SERVICE No. 453		BULLETIN October 13, 1961	MODEL SPORTSTER	Dealer Information O Product C
-------------------------------	---	---	-------------------------------	-----------------------------------

XLCH MODEL FUSE ELIMINATED

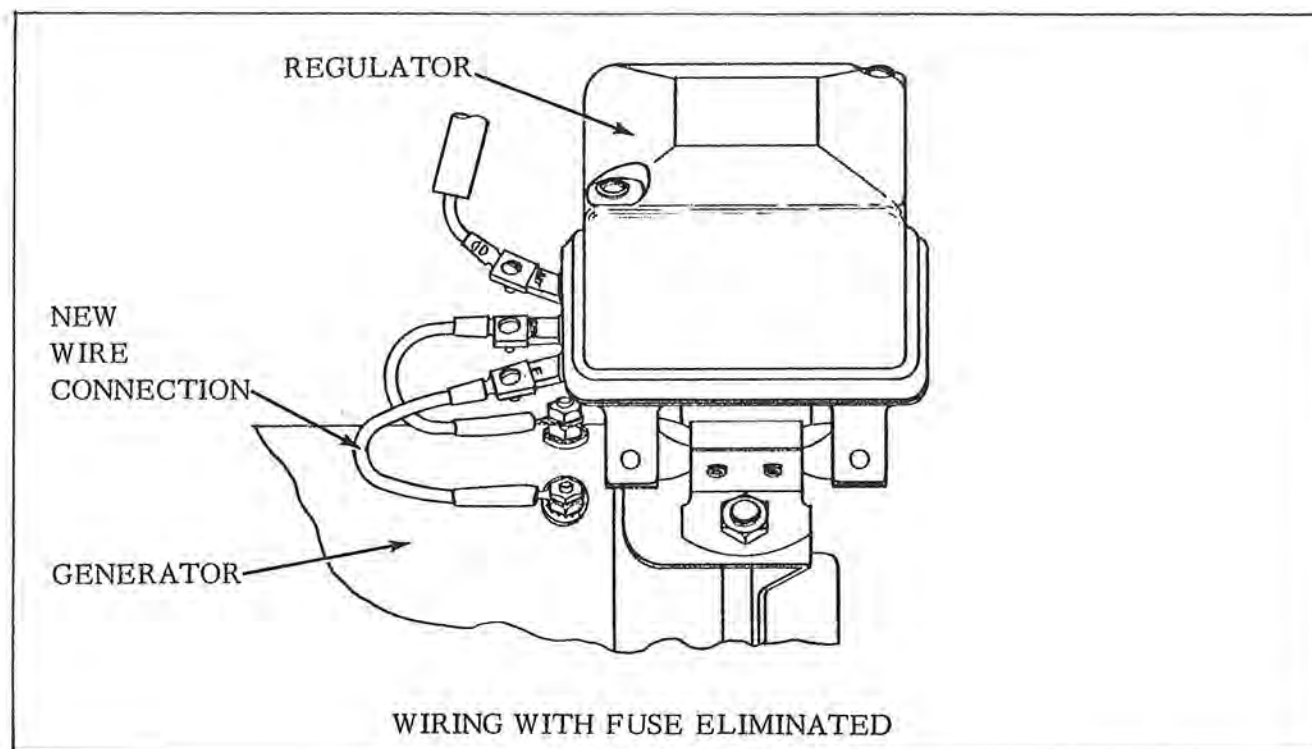
The fuse located at the base of the Sportster XLCH voltage regulator has been eliminated on all Sportster XLCH motorcycles shipped from the factory starting September 21, 1961 with Engine No. 62 XLCH 2481.

It is recommended that this modification be made on all magneto equipped Sportster XLCH motorcycles in the field to make the electrical system more reliable.

Disconnect the green wire with fuse and fuse holder and substitute a short wire, Part No. 70251-52, directly between the generator field (F) terminal and the regulator field (F) terminal. See diagram.

If short wire is not available, cut the green wire off approximately 1-1/2 inches from each end terminal, splice wire ends and tape spliced connection to insulate it.
